**AMENDMENT 3 \_VA DESIGNATION  
(ADDENDUM # 2 –Design Team)**

**Issue Date:** 31 August, 2012

**LONG TERM/INTERMEDIATE PSYCH UNIT**  
4801 Veterans Drive  
St. Cloud, Mn.

**OWNER:**  
**VA MEDICAL CENTER – ST. CLOUD**  
4801 Veterans Drive  
St. Cloud, Mn.

**CASEWORK NOTES**

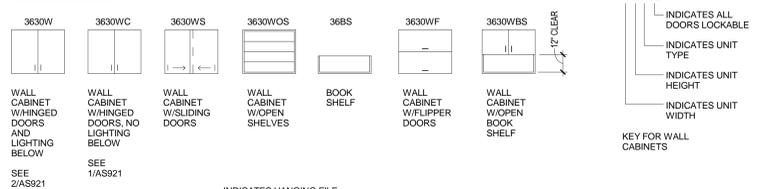
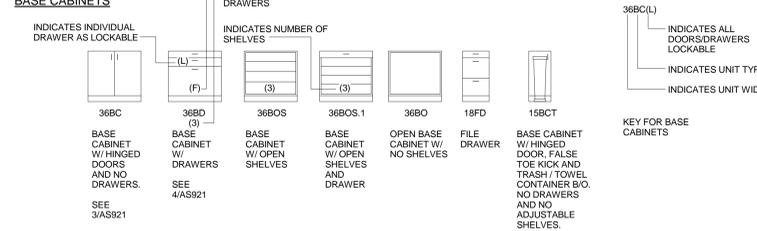
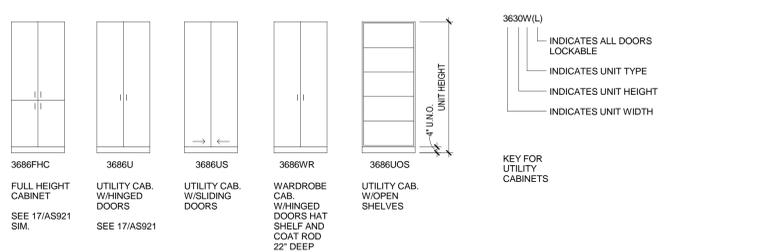
- 2-23. Revise Casework Notes as shown.

2-24. Revise Casework notes as shown on AS901 drawing.

PROJECT TITLE	DATE	DATE
LONG TERM / INTERMEDIATE PSYCHIATRIC UNIT	03/15/2012	03/15/2012
PROJECT NO.	PROJECT SCALE	PROJECT NO.
1032.001.00	As indicated	1032.001.00
DRAWING NO.	CHECKED	DRAWING NO.
AS921	Author	AS921

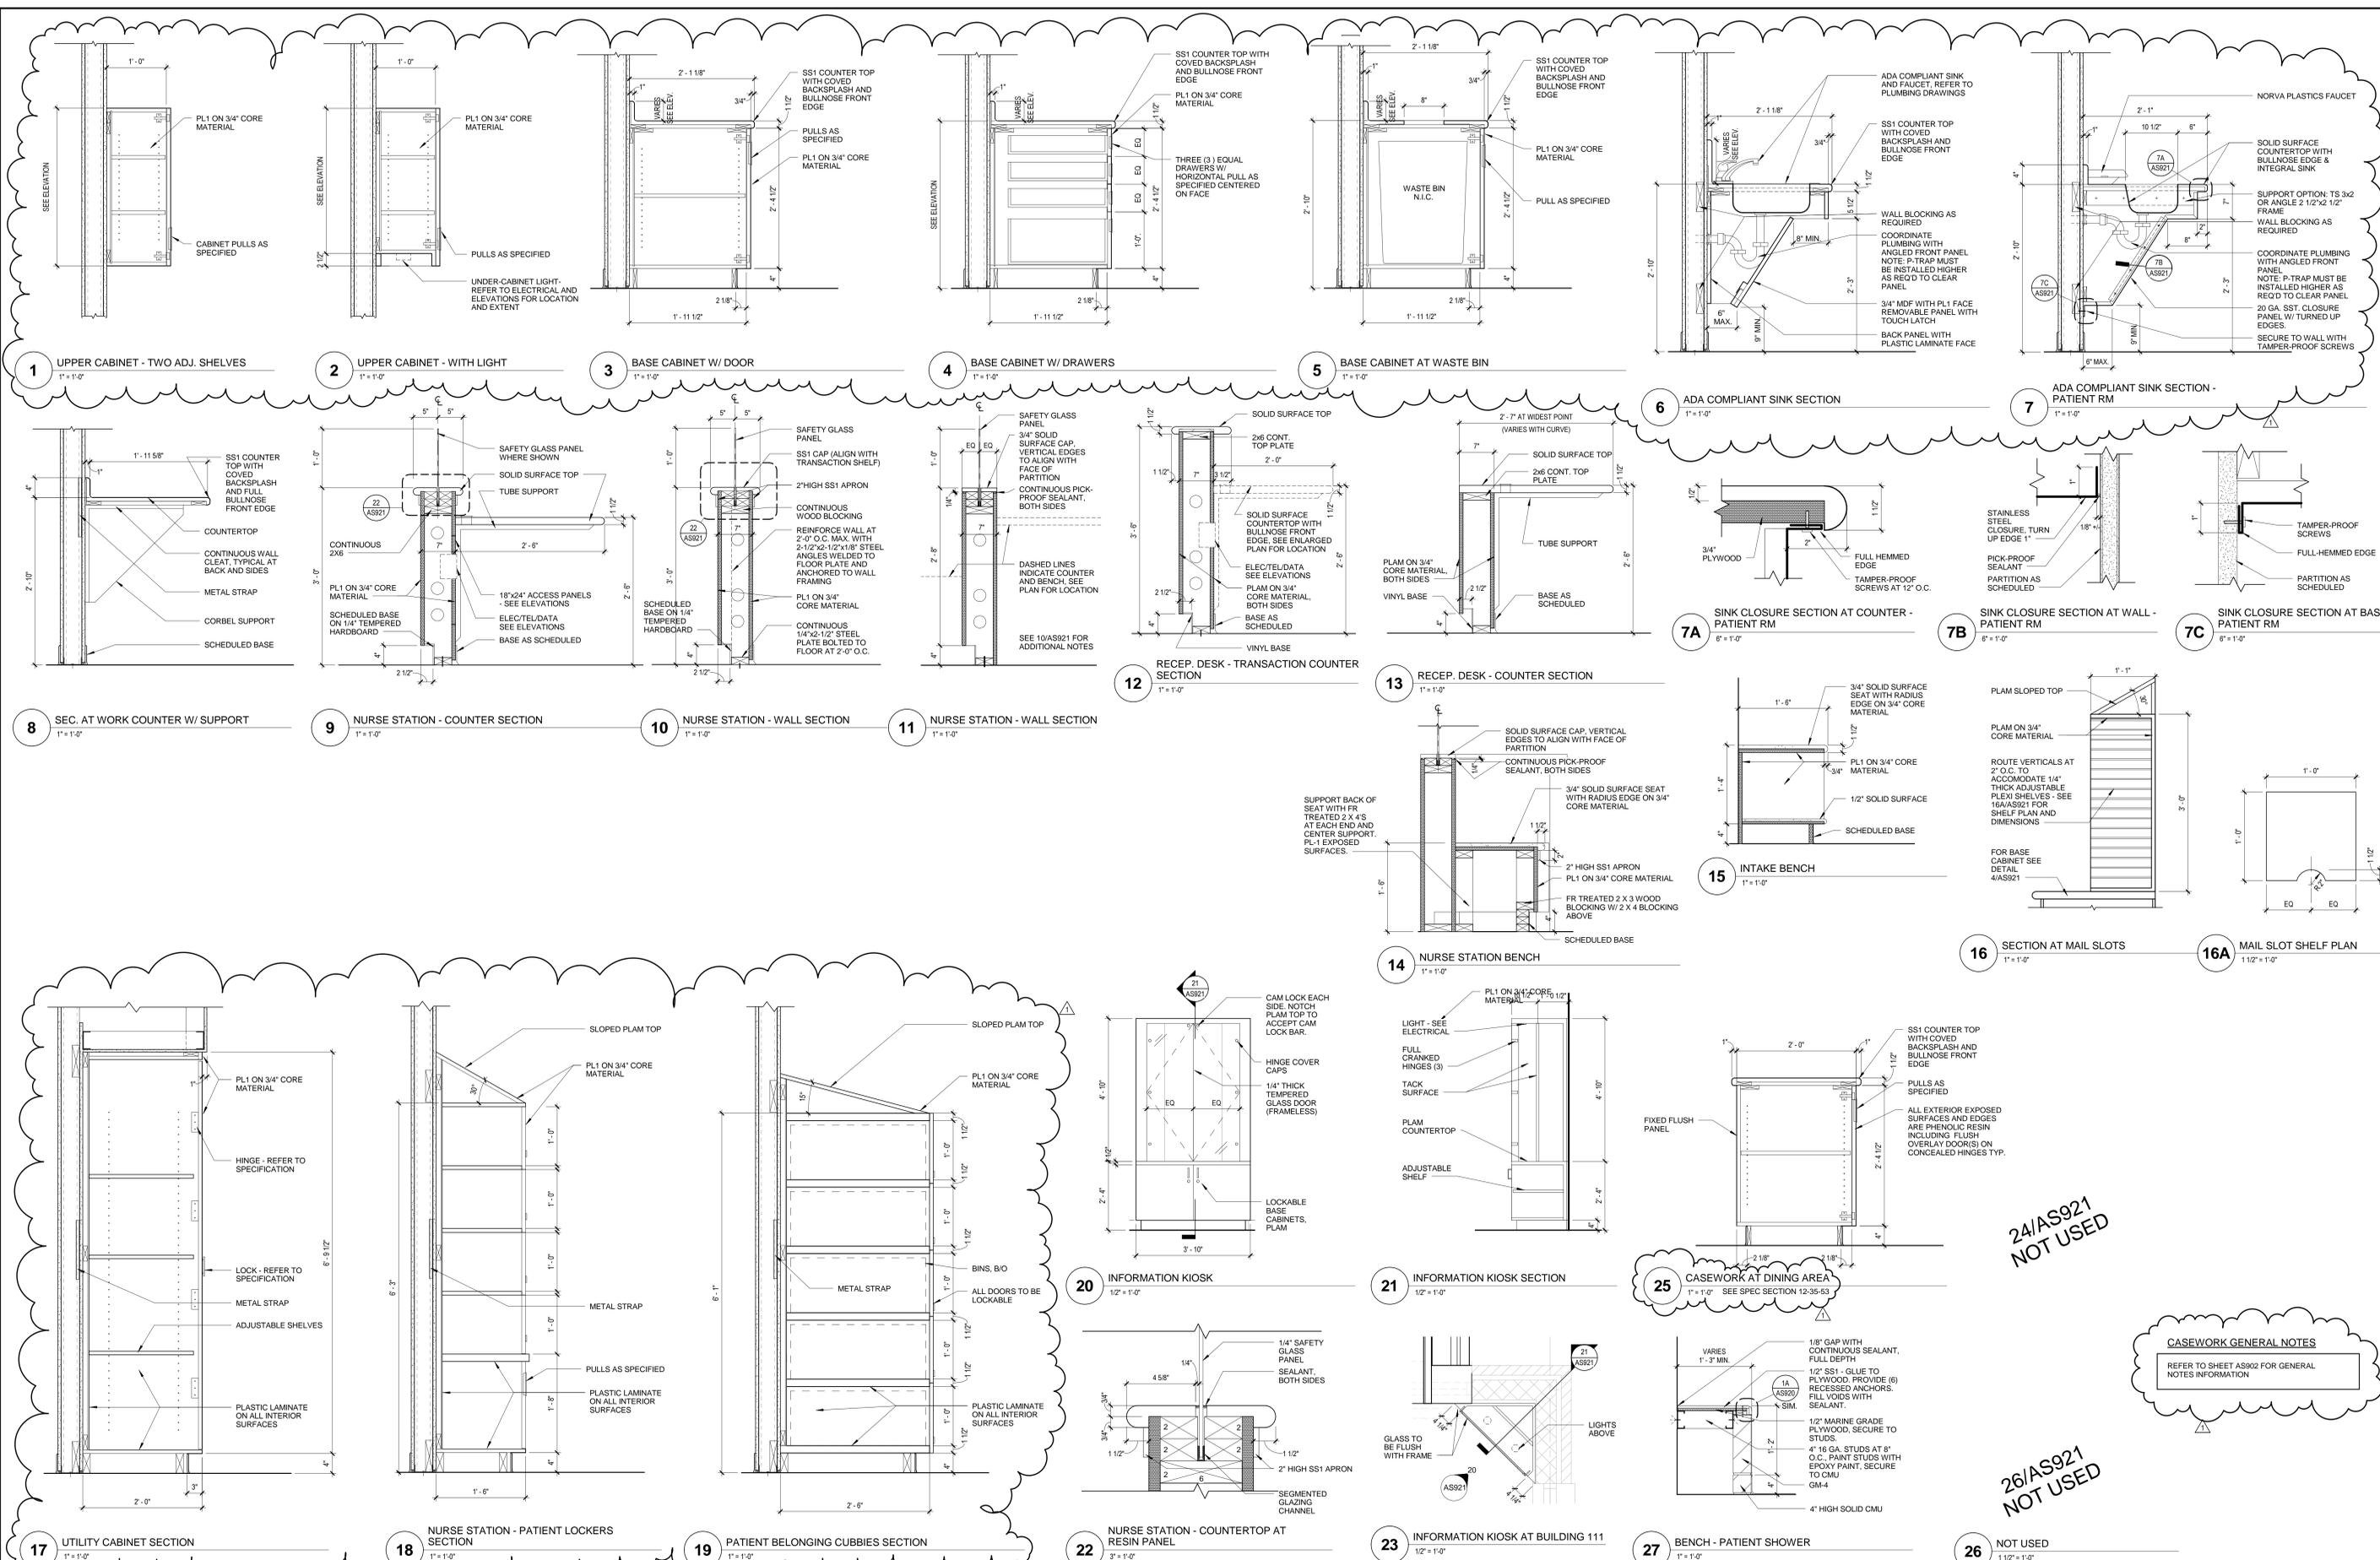
2-25. Revise details as noted .
